BOARD OF TRUSTEES WORK SESSION
11004 Carpenter Street, Mokena, Illinois 60448
Tuesday, September 5, 2017

Crash Champions

19600 Schoolhouse Road

The Oaks Townhomes

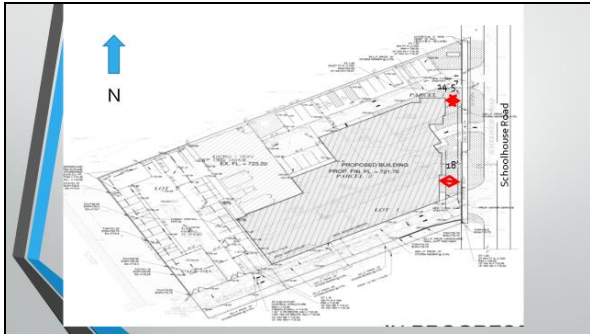
- Village regulations require all buildings within the I-1, Light Industrial zoning district to be 100% masonry on the front elevation, and 75% on the remaining elevations.
- The front of the proposed building consists of metal wall panels, exterior insulated finish system (EIFS), face brick, split face block, and metallic wall coverings.
- The elevations show that the remaining portions of the building are to be constructed of steel wall panels with a split face block knee wall on many portions of the steel walls.

- The Village has preliminarily designed a road widening project for Schoolhouse Road from 191st Street to LaPorte Road.
- Due to right-of-way constrictions in several areas along this road, the widening project has been put on hold.
- In order to address a minor right-of-way constriction on this property, Mr. Ebert is proposing to dedicate an additional eight feet for roadway purposes.
- This has resulted in the need for a front yard setback variation. The minimum front yard setback in the I-1, Light Industrial zoning district is 30'. The site plan shows a varying front yard setback of 14.5' to 18' along Schoolhouse Road.

- Village regulations require landscaping along all property lines and the foundation of the building.
- The petitioner requests variations from these regulations along the west property line and along the southern perimeter of the new building addition.
- Currently, there is no landscaping within these areas. However, if this proposal moves forward, a variation from the landscaping regulations is required because the pavement goes to the property line and building walls.

- Is the Board in favor of this redevelopment proposal?
- Is the Board comfortable reducing the masonry requirement?
- Is the Board comfortable reducing the setbacks?
- Is the Board comfortable reducing the landscaping requirements?
- Should the proposal be forwarded to the Planning Commission for a Public Hearing?

Discussion: The consensus of the Board was favorable to the redevelopment proposal including the requested variations related to masonry materials, setbacks along

Schoolhouse Road and landscaping. The Board directed the petition to the Planning Commission for a formal public hearing.

Second Revised Design

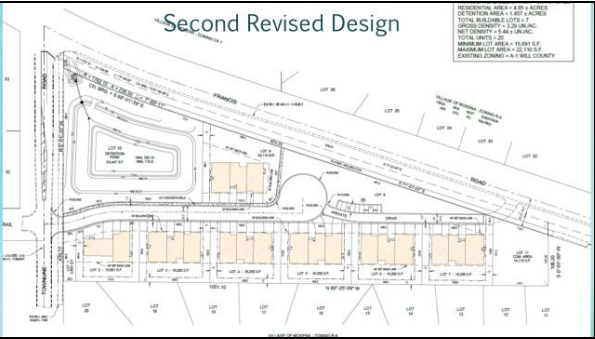
- **Lot Size** - Zoning Ordinance requires 6,250 SF of land/dwelling unit.
 - Lots 3 thru 7 are slightly below the minimum lot size requirement.
 - Lot 11 is 14,115 SF with no dwelling units on it. As a result, the overall density of the project is lower.
- **Density** - After recalculation, now 5.35 DU/per acre.
 - Reducing street width, eliminating the units' footprints, and providing green space has accounted for the change.

- **Access** – Proposal includes a long, private, cul-de-sac road and one private drive.
- **Utilities** – Available, adequately sized, and within proximity to the subject property.
- **Drainage and Detention** – Petitioner required to provide detention.
 - A wet-bottom detention area is shown on Lot 10.
- **Landscape Buffer** – A line of mature evergreen & deciduous trees, as well as bushes, on the northern perimeter of the single-family Oaks Subdivision

- **Setbacks**
 - Rear and side yard setbacks comply with the minimum setback requirements for the R-6 zoning district.
 - Rear yard setback on the third conceptual plan has been increased from 30' to 40'.
 - Side yard setback is 15'.
 - Front yard setback of 20' does not comply with the minimum 30' front yard setback requirement.
 - Flexibility regarding design standards can be granted with Planned Unit Developments.

Discussion: The consensus of the Board was that the density of the project was now acceptable and that the project could move forward through the Village’s development reivew process. The Board did ask that additional landscaping be added where needed along the south property line and that stone “rip-rap” be used around the stormwater retention pond.
